STATE OF WASHINGTON  
DEPARTMENT OF ECOLOGY

Re: The Department of Ecology Decision on Further Investigations at the Landsburg Mine site, Ravensdale

### **Summary and Recommendations on Issues of Additional Investigation at the Landsburg Mine site in Ravensdale**

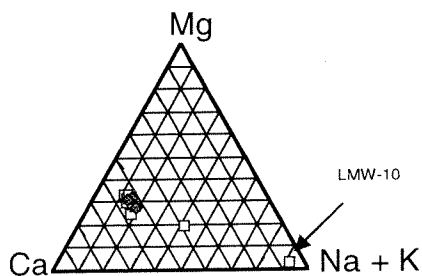
- 2) The well or wells may serve as early warning or sentinel well(s) in the possible event of a release from the source area in the trench. For example, in the event of an earthquake, the buried drums may potentially shift and rupture. Therefore, the deep well(s) may be monitored for contaminants to track contaminant transport.
- 3) The well(s) may be used for remediation or to extract mine water, thus lowering the water table and providing inward hydraulic gradients that will prevent breakout of potentially contaminated mine water.
- 4) There is evidence that deeper groundwater at the site is geochemically different from shallow groundwater based on major cation compositions. For example, the deep northern well LMW-10 that is screened at an elevation of 338.5 feet above sea level is richer in the alkalis Na + K and lower in Ca and Mg compared to other waters:

Data for the above graph was taken from the May 2004 groundwater analytical results. LMW-10 was a recently installed deep well. At present, we cannot preclude the high Na and K to be artifacts of the well installation process (from bentonite seal or from material in Portland cement used to fill the borehole beneath the well screen). Coupled with an upward hydraulic gradient at the discharge (portal) areas, this points to a complex flow system with upward groundwater flow from deeper levels. If there is contaminated water at these deep levels, based on the results of LMW-10, it may be expected that deeper waters may reach the shallow levels that affect groundwater use and surface water quality. Therefore, there is a need to identify the water quality emanating from the deeper region of the former mine.
